Reply on RC2

Author comment on "Cost–benefit analysis of coastal flood defence measures in the North Adriatic Sea" by Mattia Amadio et al., Nat. Hazards Earth Syst. Sci. Discuss.,
<https://doi.org/10.5194/nhess-2020-414-AC2>, 2021

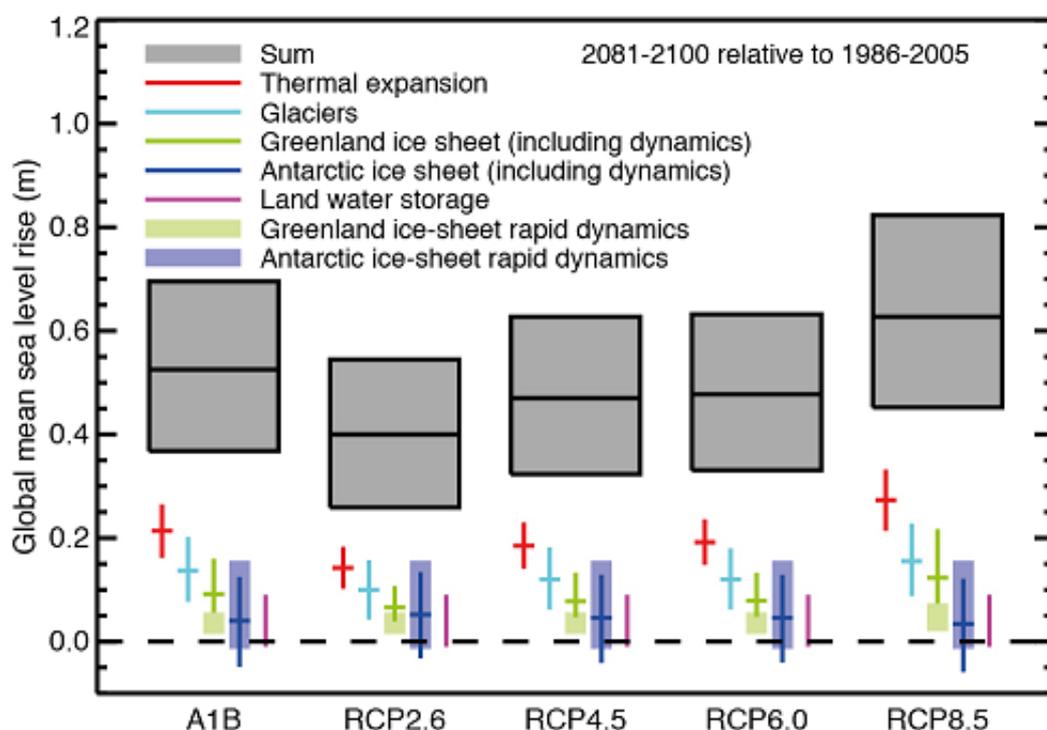
Line150: The authors used RCP4.5 for the future projections of SLR. It would be interesting to see what happens with RCP8.5.

- Thank you for this suggestion. It would have been interesting to explore additional SLR scenarios, however the scenario analysis was constrained due to time and funding limitations, which in turn depend on the preferences of the stakeholders. As a result, it has been agreed with the Municipality of Rimini to simulate only one RCP scenario (RCP 4.5, selected as the “average”), but to consider a wider range of flood probabilities in term of return periods (i.e. 1, 10, 100, and 250). We think the one scenario that could be added in future work to extend recommendations is the RCP 8.5 at 2100, as the same scenario at 2050 does not differ significantly in terms of global SLR with respect to the RCP 4.5, while the scenario RCP 6.0 doesn’t differ in terms of SLR significantly also at 2100.

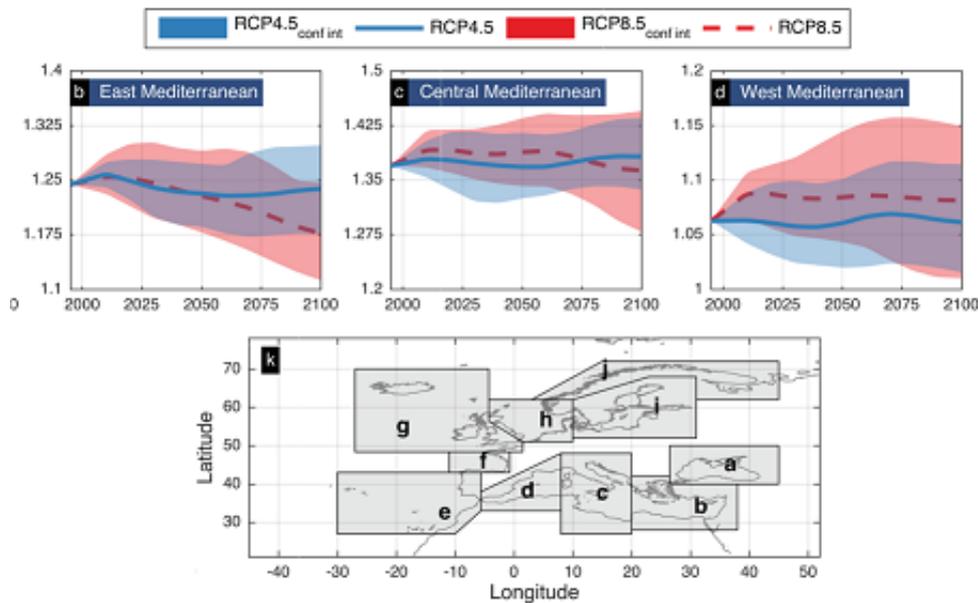
Line 150-152: Moreover, IPCC AR5 SLR projections give more local projected values of SLR. Apart from using a generic Global Mean Sea Level rise projection for the Mediterranean area, it would make more sense to account for more regional/local SLR values at specific coastal areas (as in IPCC AR5).

- Thank you for your valuable comment. We believe that in our analysis we do account for both local SLR historical observations at coast and specific downscaled projections for the central mediterranean basin. We have taken into consideration your comment and have amended par 3.3 to address these points more clearly:

We believe the dataset obtained from "Vousdoukas et al (2017) - Extreme sea levels on the rise along Europe's coasts" currently represents the best SLR estimate available for EU countries in alignment with the RCP framework:

Projections of RSLR indicate a statistically significant increase in MSL along the entire European coastline. The average RSLR across Europe is projected around 21 and 24 cm by the 2050s under RCP4.5 and RCP8.5, respectively. RSLR is projected to accelerate during the present century under both RCPs, reaching 53 and 77 cm by the year 2100 [...]. The RSLR projections show higher model agreement for the Mediterranean Sea and the Atlantic coast [...].
